STATE OF MISSOURI
DEPARTMENT OF NATURAL RESOURCES

November 10, 1993

The MDNR (Missouri Department of Natural Resources) has reviewed the following documents for the FUSRAP (Formerly Utilized Sites Remedial Action Program) St. Louis Site, submitted under cover letter dated July 21, 1993 by the U.S. DOE (Department of Energy):

SUBJECT: Site Suitability Study for the St. Louis Airport
Site; St. Louis, Mo.; FUSRAP; July, 1993; prepared
by Bechtel National, Inc.

Figure 9-25

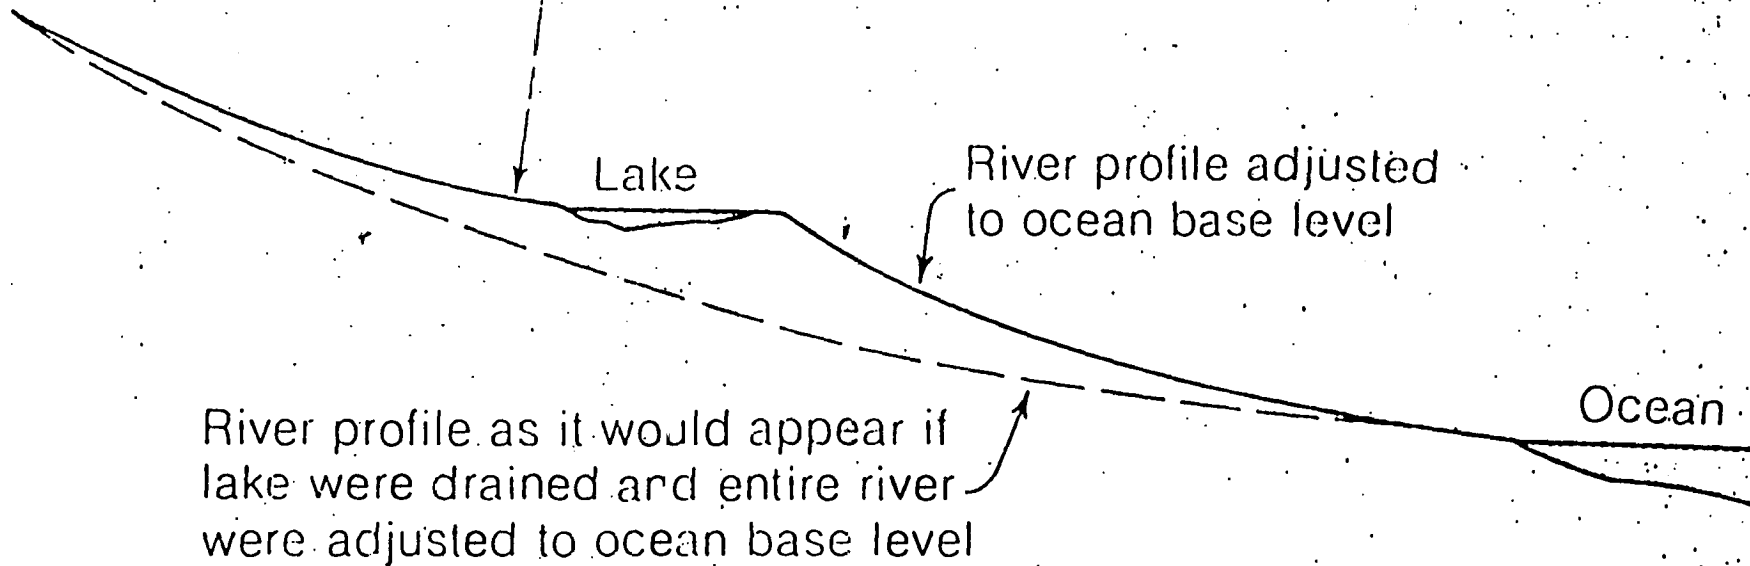
This report contains some good graphics and shows that the sediments in the Coldwater Creek channel are slowly moving toward the Missouri River. One important graphic that is missing from the draft is a longitudinal profile of Coldwater Creek. A longitudinal profile would show that the valley of Coldwater Creek Valley is still developing as it adjusts to a new base level-the Missouri River. The current profile reflects the relatively recent influence of a Pleistocene lake. This lake no longer exists, allowing Coldwater Creek to erode downward. The situation is depicted in the enclosed diagram taken from Earth, 1972, by Frank Press and Raymond Siever. In the case of Coldwater Creek, regional base level is the Missouri River instead of the ocean. The models presented in this draft are based on the assumption that the Coldwater Creek channel is stable. The stream profile suggest this assumption is incorrect.

Coldwater Creek has yet to adjust its stream profile to changes that have occurred in the geologically recent past. The biggest change is the deposition of fine-grained lake deposits during the Pleistocene. The first paragraph mentions that Coldwater Creek is "very steep" above its confluence with the Missouri; however, the full implications of this non-equilibrium profile are not fully appreciated throughout the document. The "higher sediment carrying capacity" attributed to sediment deficiency is probably more a result of the stream trying to reach a profile that is in equilibrium. The stream is degrading and moving sediment downstream because base level has been lowered, not because "relatively clean water" is coming from under the airport;

The conceptual model does not even mention that the stream is in the process of adjusting its bed to a new profile. The numerical/emperical models chosen are for a graded stream with a concave-upward profile.

The statement that Coldwater Creek is a "relatively stable stream" may be true on a human time scale of a few hundred years, but on a geologic time scale the stream is relatively unstable. The current concavity of the stream profile will be adjusted to the new regional base level. The bed of Coldwater Creek will be eroded to a new profile, a profile that is steeper on the upgradient end of the watershed.

The prediction of increased degradation downstream resulting from dredging is indeed correct. But if the stream will "re-equilibrate" to a small amount of dredging, why does it not "re-equilibrate" to the lower base level present since the Pleistocene lake disappeared. This new base level is the Missouri River.
